## DEVELOPMENT APPLICATION ASSESSMENT REPORT

Application Number:	DA2021/1744
Responsible Officer:	Maxwell Duncan
Land to be developed (Address):	Lot 13 DP 300716, 153 Queenscliff Road QUEENSCLIFF NSW 2096
Proposed Development:	Alterations and additions to a Dwelling House
Zoning:	Warringah LEP2011 - Land zoned R2 Low Density Residential
Development Permissible:	Yes
Existing Use Rights:	No
Consent Authority:	Northern Beaches Council
Land and Environment Court Action:	No
Owner:	Domenico Capogreco
Applicant:	Rapid Plans Pty Ltd

Figure 1 - West elevation envelope non-compliance

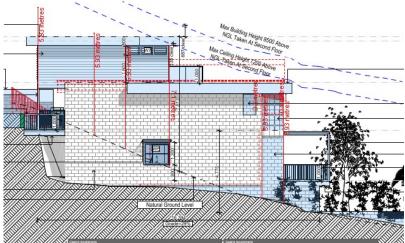
Western elevation:

• The 1.255m portion of the western wall at ground floor level, ranging from 0.2m - 0.4m in height with a maximum variation of 24%

Figure 2 - East elevation envelope non-compliance

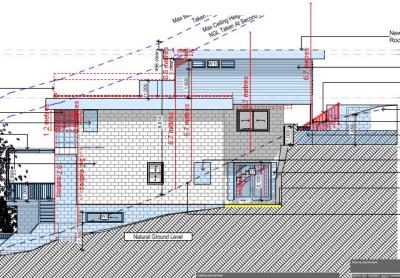
Eastern elevation:

• Two portion of the eastern wall at first and second floor floor level with a length of 1.255m and 1m, a a height ranging from 0.5m - 0.8m - 1.2m in height with a maximum variation of 8%.

The variations are generally a result of the rear-to-front slope on the site, while the larger variations on the eastern side of the development are also a consequence of an increasingly-diagonal cross-fall beneath the central/forward parts of the proposed dwelling.
